MEMORANDUM

From:	Brigitte Crafer Landscape Architect		
Service	WBC Landscape and Trees	App No:	251486
Address:	Land west of Edney's Hill, Barkham Road, Barkham.		
Proposal:	Full application for the proposed erection of 16 no. dwellings with new access off Edney's Hill, plus footpaths, car ports, parking, landscaping and associated works.		
Type of Development:	Major Dwellings (10+)		
Site Visit Made:	Yes/No

Conclusion - response to para. 4.1.9 of the LVA;

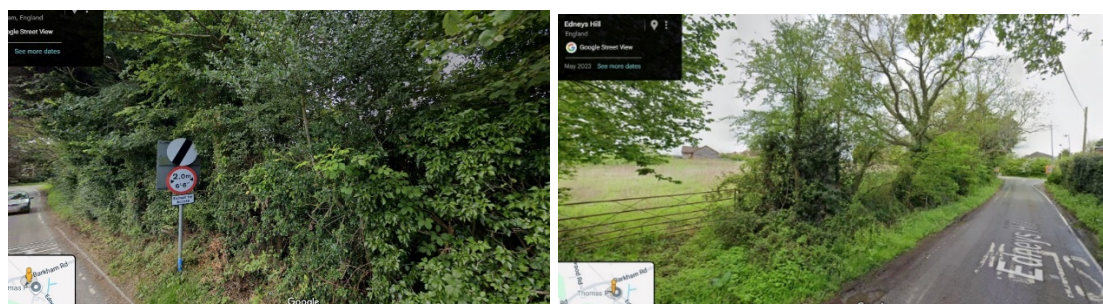
The landscape proposals do not respond sufficiently to the whole character and context or respect the character and appearance of the site in the landscape. It will be difficult to mitigate the visual effects with the majority of the views experiencing

a very high magnitude of change. The scale and type of development proposed is unsustainable in terms of its landscape and visual impact, the relationship of dwellings to the existing topography, and the location of the proposed access.
